SCHURTER AG
CH-6002 Luzern
www.schurter.com

PRODUCT CHANGE NOTIFICATION

Product hierarchy no. *				Part no.	SBU	Type / Description	Customer part no.
SBU	PG	PGU	Type				
02	005	116	0000001168	See list below	Power Entry Modules w/o Filters	DD21

Enlarging of the fusedrawer slot.

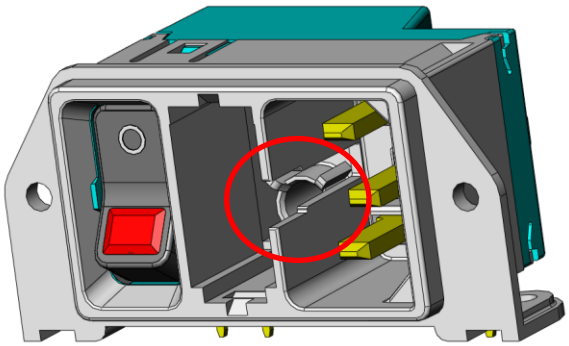
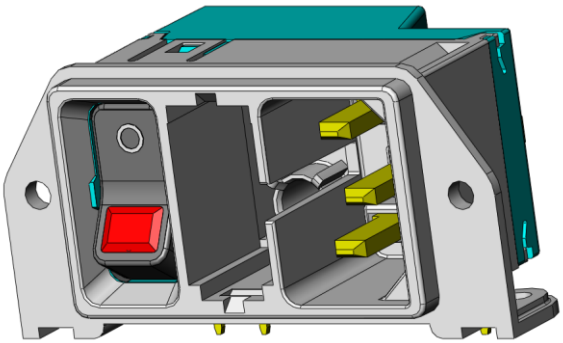
Fusedrawer slot enlarged.

Implementation of V-Lock cord retention function.
Precondition: new fusedrawer required (see PCN 0118.2133).

Form:	New form is fully backwards compatible (can be used with old fusedrawer, see PCN 0118.2133).
Fit:	n/a
Function:	The new expanded slot allows applying V-Lock cord sets for cord retaining (new fuse drawer necessary).
Production Site:	n/a
Product Label:	n/a
